From: Mary O'Neil
Sent: Thursday, March 28, 2013 12:27 PM
To: Nic Anderson
Subject: FW: 110 Riverside
Attachments: 2012-3-13 Traffic Brief Update.pdf

From: Guillermo Gomez
Sent: Thursday, March 28, 2013 12:27 PM
To: Mary O'Neil
Subject: RE: 110 Riverside

I received the attached update to the Traffic Brief for 110 Riverside on March 15th. After reviewing it, we still had some concerns, which we discussed with Abby Dery from Trudell Consulting Engineers in a meeting last Tuesday, March 26th.

Introduction

Figure 4: Peak Hour Traffic Increase

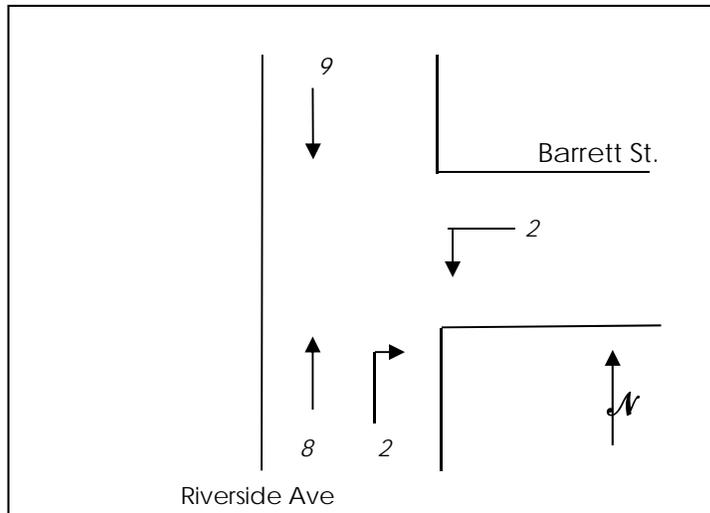
- Another concern identified during the initial review was the impact that the traffic generated from the development would have on the intersection of Riverside Avenue and Barrett Street. The consultant provided a Level of Service analysis and evaluated the queue length and the delay on the intersection and the conclusion is that the impact on the queues and delay are not significant. This issue needs no further discussion
- Staff has identified a concern regarding the gate proposed to access the underground parking. There is the potential for vehicles to block the sidewalk on the westernmost driveway while they wait for the gate to open, and during rush hour, this could translate into vehicles queuing and blocking the traffic flow on Riverside Avenue.
- DPW staff will need to see a design addressing these issues and time to review it before approve the project in terms of traffic.

Site Plan

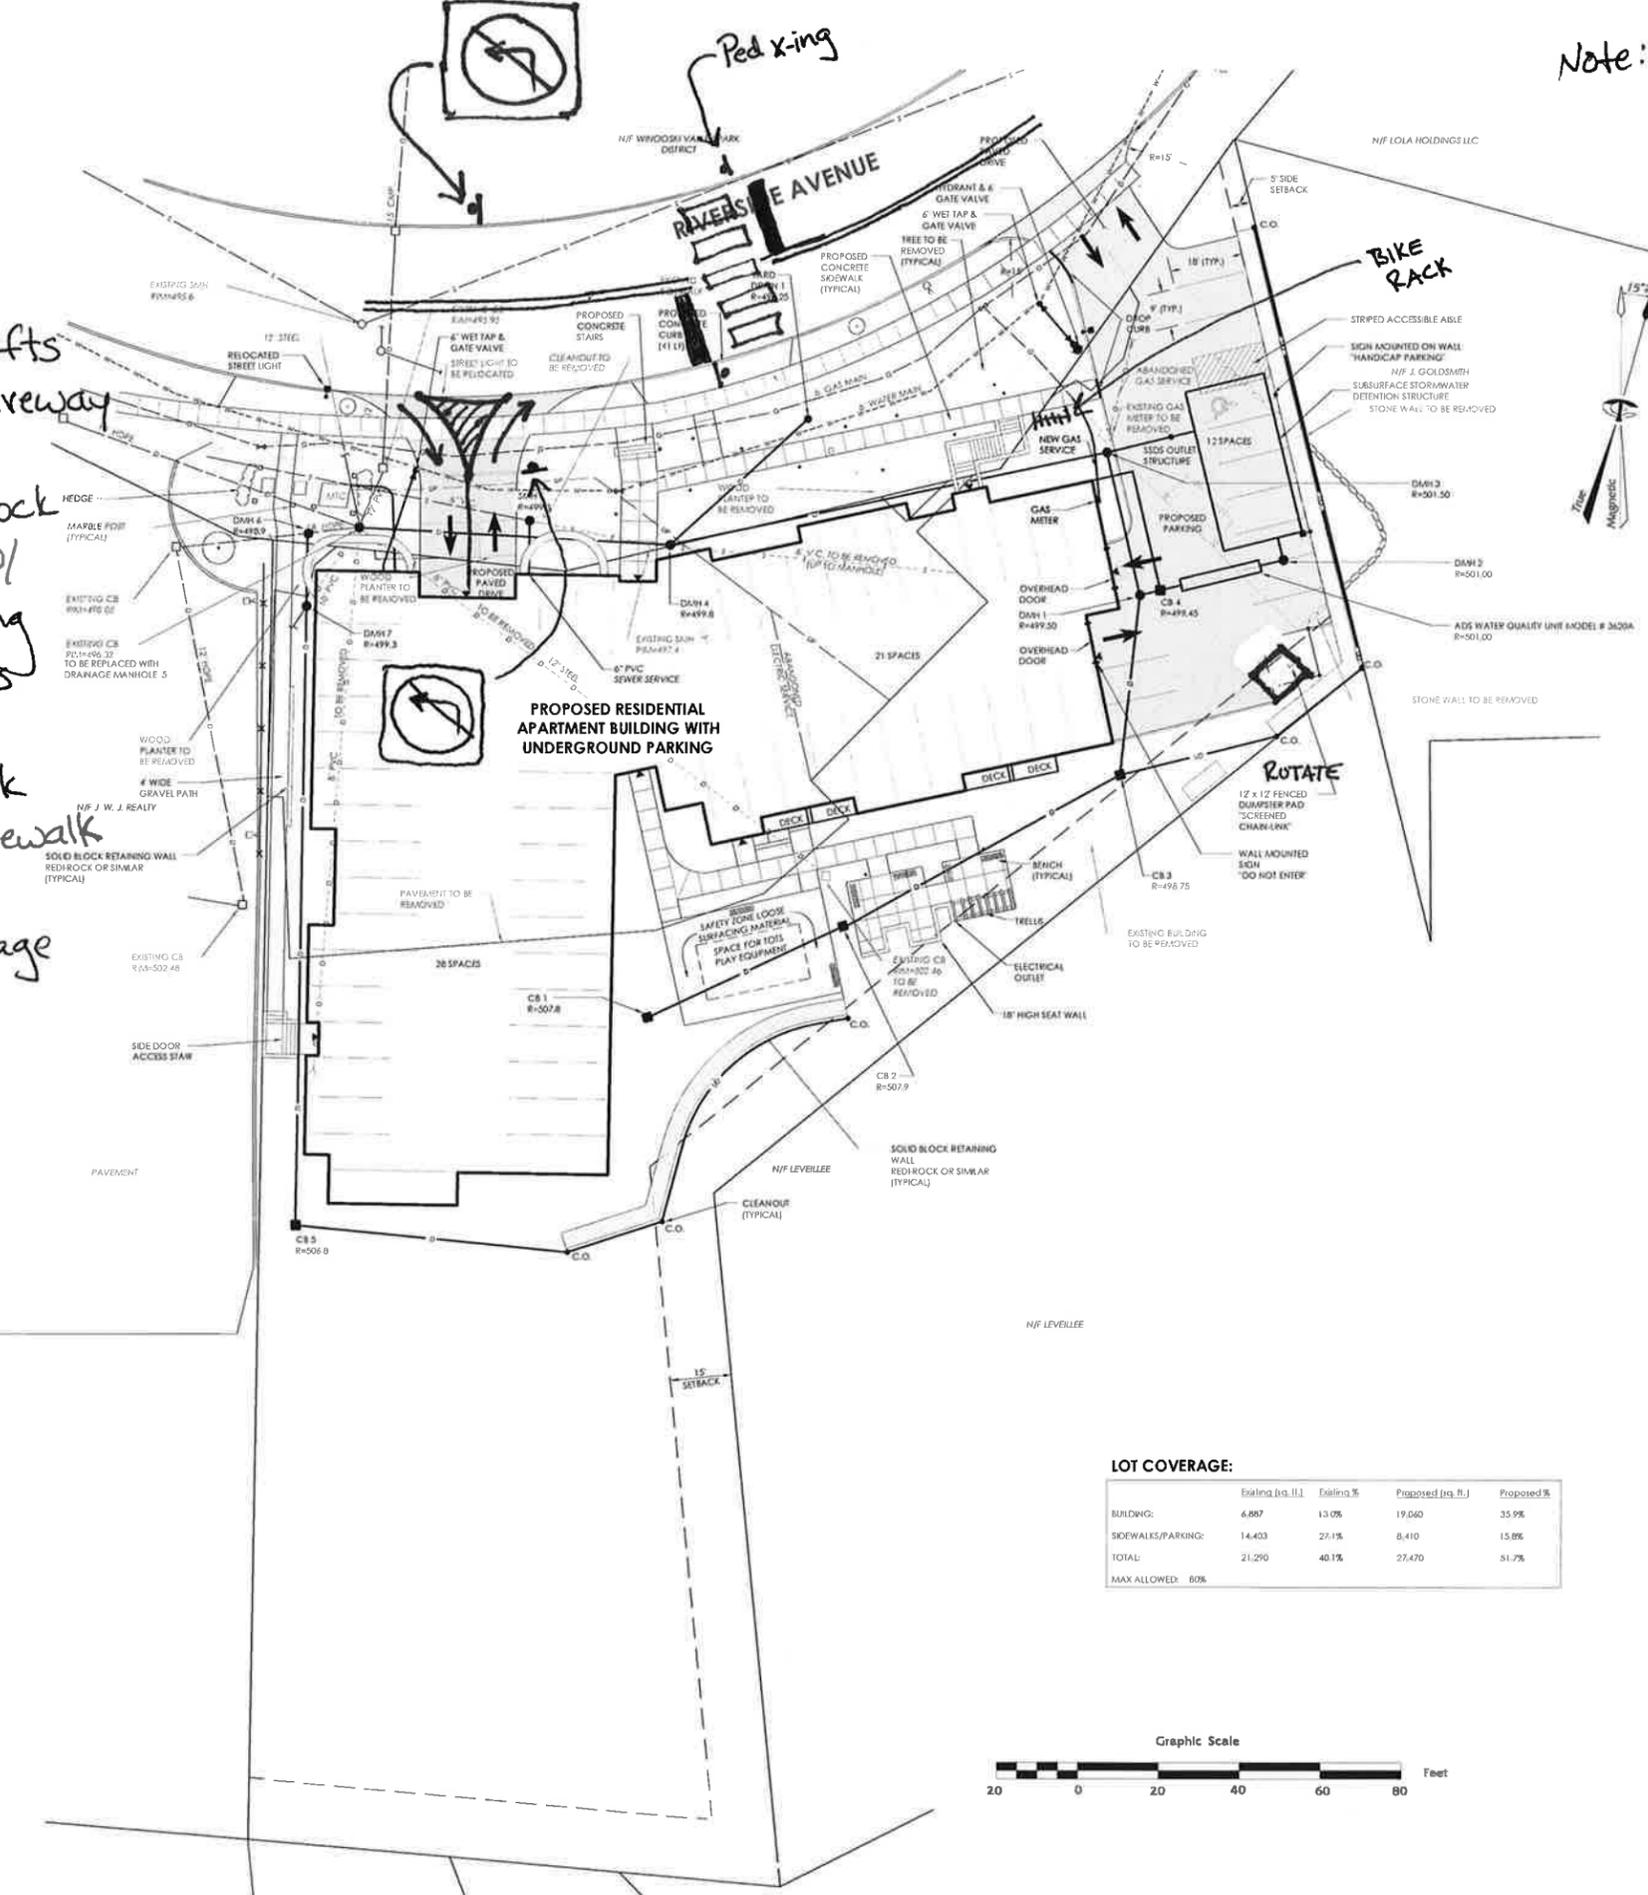
- The Initial Traffic Impact Analysis submitted by the Consultant provided an analysis of the proposed conditions and impact of the development on the surrounding area. One of the most significant concerns that came from the initial report submitted is the lack of pedestrian connectivity. The nearest pedestrian crossing is several hundred feet west of the development, and any pedestrian wishing to cross Riverside Avenue to walk towards Winooski would have to walk several hundred feet west to cross and then back. Instead of doing this, pedestrians would likely cross directly in front of the development in an unsafe way. DPW asked the consultant to provide a sight distance analysis to ensure that vehicles have enough time to react to a pedestrian or a vehicle leaving the development. DPW also suggested the consultant to examine the feasibility of providing a pedestrian mid-block crossing. DPW believes having two driveways at this location is not necessary, though it may provide a higher level of convenience to residents to the proposed development, it further complicates the safe accommodation of the pedestrian crossing for this project. In response our initial comments, the Consultant provided an updated Traffic Impact Report that includes a sight distance analysis, and proposes restricting left turn movements on the westernmost driveway (see schematic in the attached file). The Consultant concluded that a pedestrian mid-block crossing is warranted, and their updated design calls for the pedestrian crossing to be positioned in between the two proposed driveways. Staff reviewed this proposed configuration and still finds it problematic. Our concern with this placement is that: exiting traffic will be centrally focused on entering the stream of traffic and not on pedestrians in the crosswalk. To further complicate the decision making for exiting traffic, they will need to contend and coordinate with three conflicting movements (entering into heavy stream of traffic on Riverside Avenue, pedestrians in the crosswalk and the second driveway in close proximity at the same property). Upon meeting with the Consultant, staff suggested restricting the western driveway to allow only a right-in movement (no exiting traffic allowed). All traffic exiting the development would have to do so through the eastern driveway. This eliminates the conflicting movements from exiting traffic on the western driveway. If this is implemented, the placement of the mid-block crossing can be reanalyzed to make sure it is proposed at the safest possible location, with adequate sight distances on all approaches and an some distance for vehicles exiting the traffic stream from the eastern driveway to enter the traffic stream and become aware of the pedestrians and the crossing.

- 1) Restrict lefts at west driveway
- 2) Add mid-block crosswalk w/ rapid flashing yellow lights
- 3) Add Bike rack to front sidewalk secure storage located at garage level
